Metro North-West Joint Development Assessment Panel Agenda

Meeting Date and Time: 26 November 2015; 10.30am
Meeting Number: MNWJDAP/110
Meeting Venue: City of Joondalup
90 Boas Avenue, Joondalup

8.1	Property Location:	Lot 9 (937) Whitfords Avenue, Woodvale
	Application Details:	Proposed three storey mixed use development
	Applicant:	Rowe Group
	Owner:	Citypride Holdings Pty Ltd
	Responsible authority:	City of Joondalup
	DoP File No:	DAP/15/00832

9.1	Property Location:	Lot 40 (6) and Lot 201 (8) Packard Street, Joondalup
	Application Details:	Amendments to approved additions to existing warehouse and new warehouse, showroom and lunch bar development
	Applicant:	Taylor Robinson
	Owner:	Gypsy Hill Pty Ltd
	Responsible authority:	City of Joondalup
	DoP File No:	DAP/15/00786

STAGE 1 ELEVATIONS

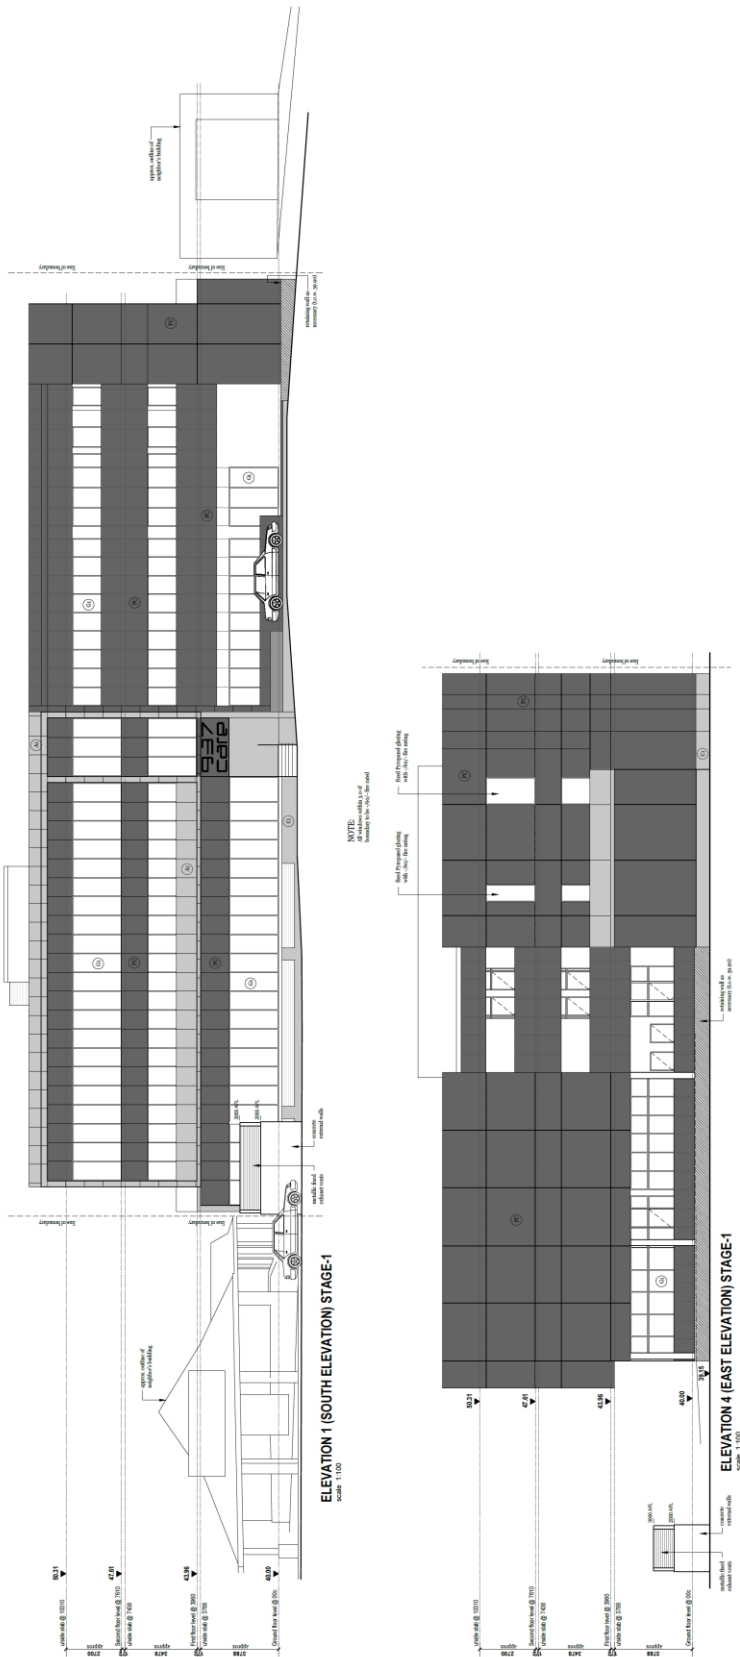
While the proposed building is setback 15 metres from the Whitfords Avenue street boundary, the development plans show a basement extract fan stack setback at 4.55 metres from the street boundary. As this fan stack is considered to be part of the building, the nine metre setback to the street boundary, as required by DPS2, has not been met. It is considered that the fan stack, with its plain concrete façade, will detract from the appearance of the building and is not appropriately integrated with the design of the development.

- The Panel noted that the ventilation stack for the car park is not shown on the elevation plans. The Panel suggested that the stack should be built into the core.

The applicant provided revised plans following the JDRP meeting which depicted the fan stack on the elevations and provided the following response to the above comments:

Elevation 3 - SouthEast Facade Along Packard Street

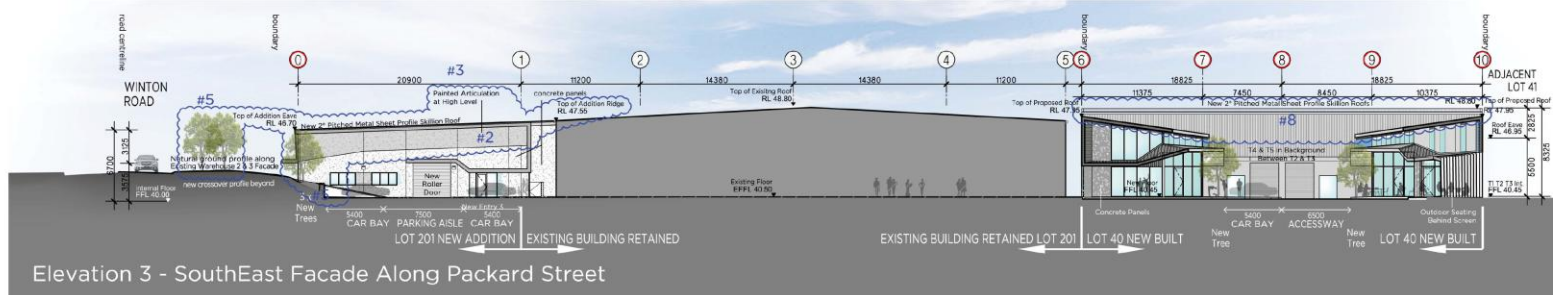
The modifications include the removal of the band of translucent polycarbonate panel clerestory windows along the top of the external concrete wall panels addressing both the Packard Street and Winton Road street boundaries. The translucent windows are proposed to be replaced with a painted/textured finish concrete wall panels.

The removal of the polycarbonate panels to the external facade of the warehouse extension and the façade now proposed is not considered to meet the objectives of the 'Service Industrial' zone. Given the setback proposed, the painted concrete panels do not provide for an attractive facade to the street, nor is it considered that these modifications ensure a positive contribution to the provision of an attractive streetscape as required within the 'Business Support' district under the draft JCCSP. It is considered that a higher level of articulation should be provided to create visual interest within the facade, and to account for the lack of other visual relief that could have otherwise been provided through soft landscaping on the site or a greater street setback. A condition of approval is recommended requiring further articulation to this facade, with details to be submitted to and approved by the City prior to the commencement of construction.
